PENRITH NEPEAN HOSPITAL REVIEW OF SUBMISSIONS AND PREFERRED PROJECT REPORT

Prepared for NSW Health Infrastructure
18 December 2009

Figure 3.1_Original and Revised Locations of Proposed Chapel (Source: HASSELL 2009)

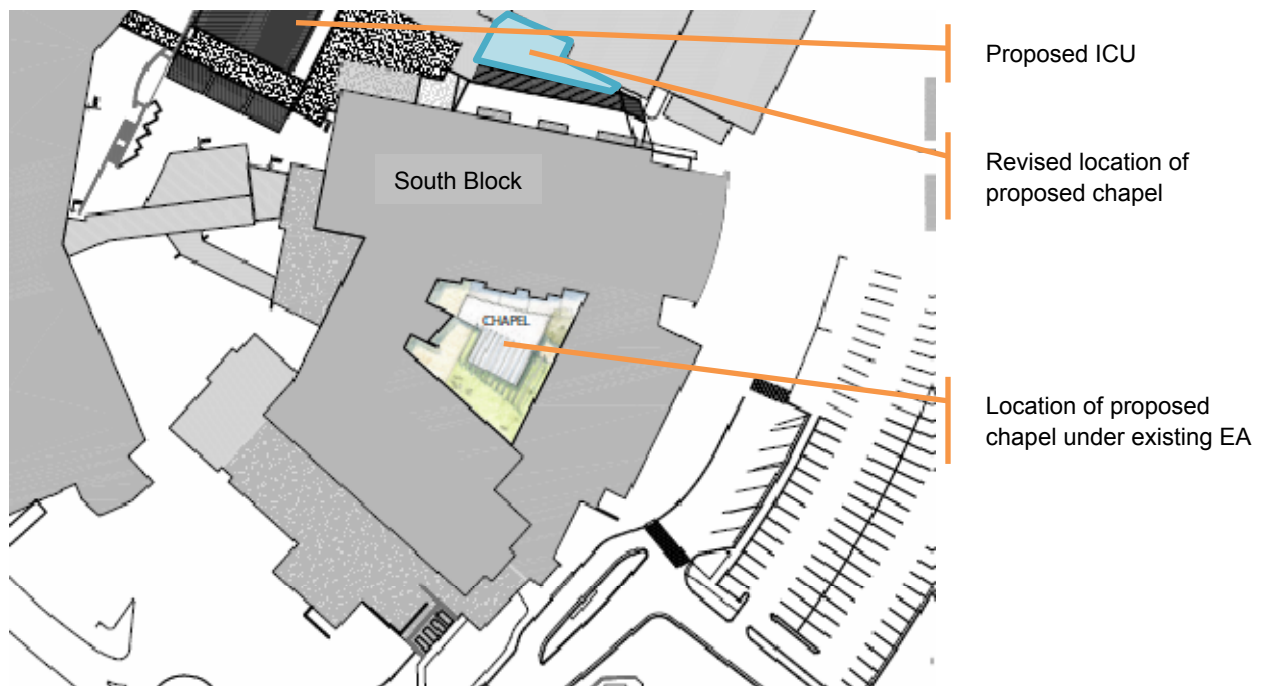
Penrith City Council requested further details and plans of the proposed chapel to be provided.

The EA included a new 'multi faith' chapel to be constructed in the existing courtyard within the South Block of the Hospital. The location of the chapel has since been revised, and is now proposed to be located to the east of the ICU Department. The location of the proposed chapel under the existing EA, and the revised location, are shown in Figure 3.1.

The visual impacts of the new location are considered to be less than the original proposal. The chapel was previously a stand alone building located in a highly visible location facing on to the main South Block entry, and the chapel is now within the internal layout of the South Block. Plans of the chapel are incorporated within the updated ICU plans provided at Appendix C of this report.

Figure 3.1_Proposed Amendment to Car Parking Plan (Source: HASSELL 2009)

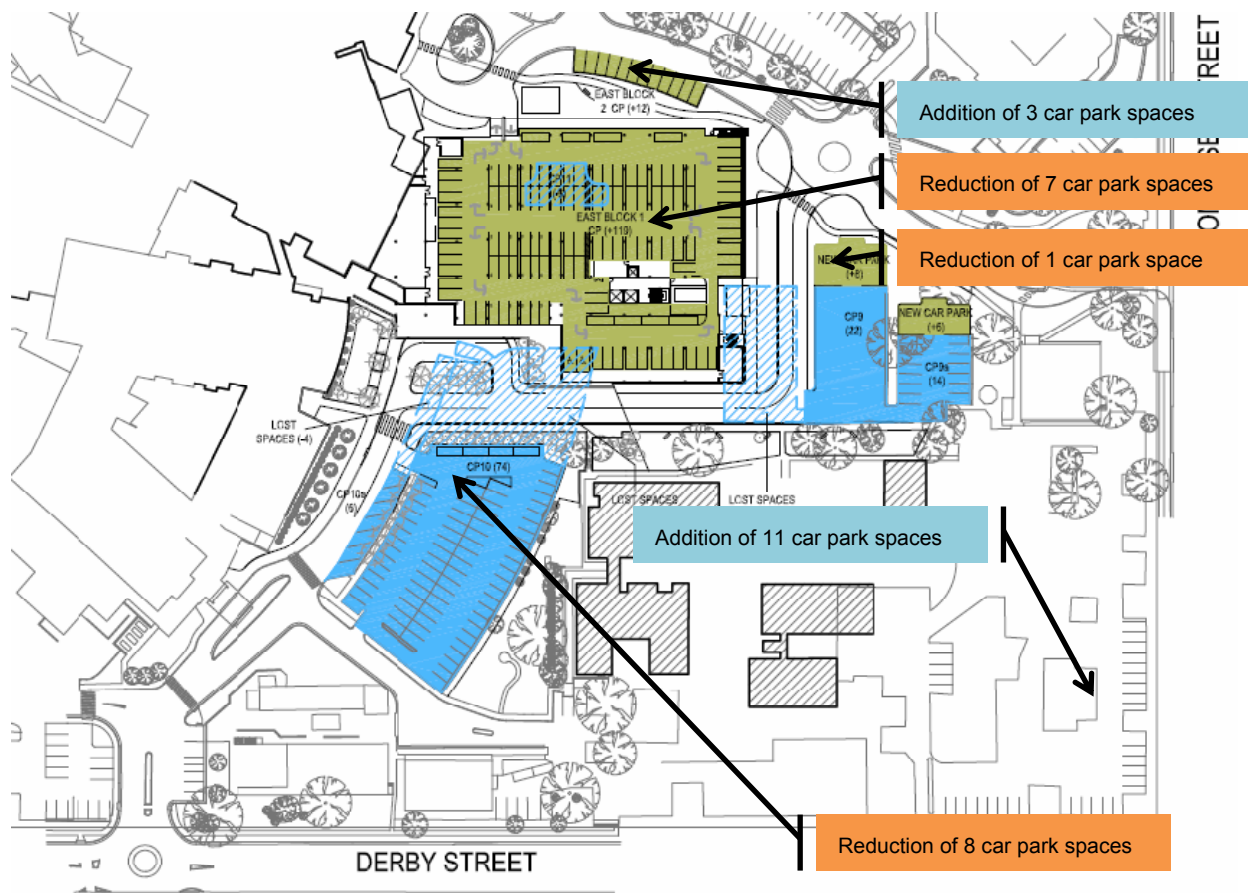
Due to subsequent changes as part of detailed development design, the car parking to be provided is amended as outlined in Table 3.2 and shown in Figure 3.1. The total number of car parking spaces to be provided is now **155**, which continues to meet the requirements under the Penrith DCP:

Modification	Reason / Comments
The internal layout of the car parking area on East Block Level 1 has been rearranged, resulting in a reduction of 7 car parking spaces on Level 1 (now 112, was 119)	The changes to the building layout of the levels above has resulted in amendment of the structural building supports in Level 1. This has lead to reduced space available, and the need to rearrange the layout and reduce the number of car parking spaces.
The alignment of the road south of East Block has been altered, resulting in a reduction of 8 car parking spaces from existing car park areas CP10 and 10a.	The road south of East Block has been re-aligned to facilitate construction (and will be of permanent construction to cater for the operational stage).
1 less additional car space provided to existing car park area CP9.	Space not achievable due to the existing levels
14 (out of 16) of the additional car parking spaces lost are to be replaced and will be provided at the following locations: _3 car park spaces north of the East Block building; and _11 car park spaces in existing car parking area CP8. The other 2 car parking spaces will not be replaced.	Plans showing the new proposed car parking layout for the site are provided in Appendix C.

A revised East Block Level 1 plan (plan reference EB-SK 100) showing the new car parking layout, and a revised East Block Parking Strategy Plan (plan reference SK 012), is provided in Appendix C to this report.
